SPECIAL AIRWORTHINESS INFORMATION BULLETIN

CE-04-85
September 10, 2004

This Special Airworthiness Information Bulletin (SAIB) provides you, owners and operators of **Diamond Aircraft Model DA 40** airplanes, with safety information regarding inspection/replacement of the fuel selector/fuel valve universal joints.

NO. MSB 40-030/1

Picture 1: Universal joint with two pins separated

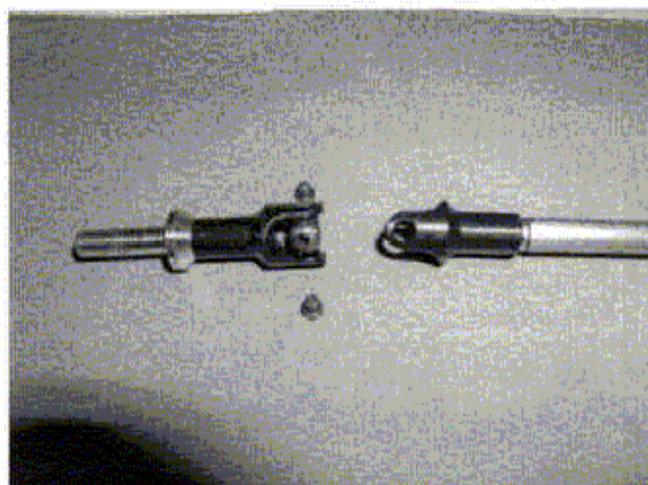
1. All works must be done in accordance with the instructions given in the AMM.
2. Remove front seat LH (AMM, Chapter 25-10-00).
3. Inspect universal joints (upper and lower) very carefully for:
 - * any sign of wear,
 - * uneven movement
 - * pins not completely pressed in
 - * loose pins

The picture below shows two of the pins separated from the joint.
Inspection can be done in assembled condition. For better view rotate fuel selector in steps at least for 360 °.

4. In case of one or more of the under 1.8.3 listed defects have been found, replace complete universal joint kit as follows:
 - 4.1 Remove front seat RH (AMM, Chapter 25-10-00)
